AEBS-HDV IWG Industry input

AEBS-HDV-08 November 30 & December 1st , 2021

AEBS deactivation - Specific HDVs need

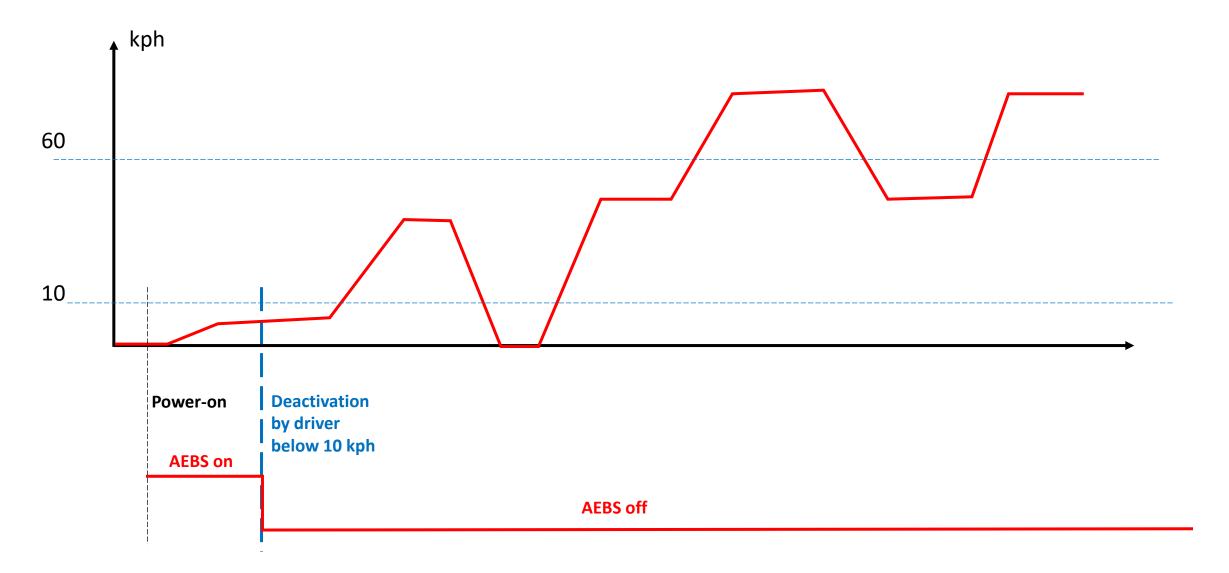
These typical cases can be addressed by the two following situations:

Situation 1

- Deactivation "Below 10kph" is manageable by the driver
- The deactivation is permanent

Situation 2

- Limited time is manageable by the driver
- Deactivation "While driving" is possible

Sensor performance impairment

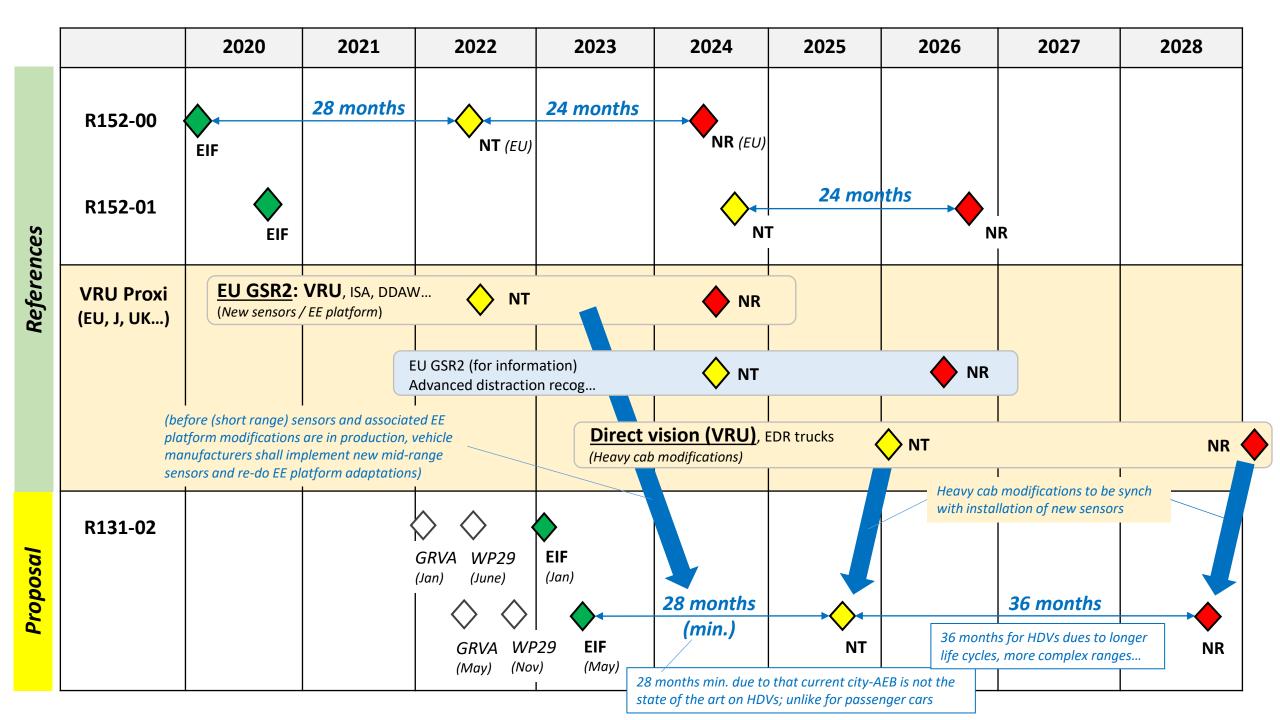
→Impairment of the sensor performance must therefore also be considered for an assistance system
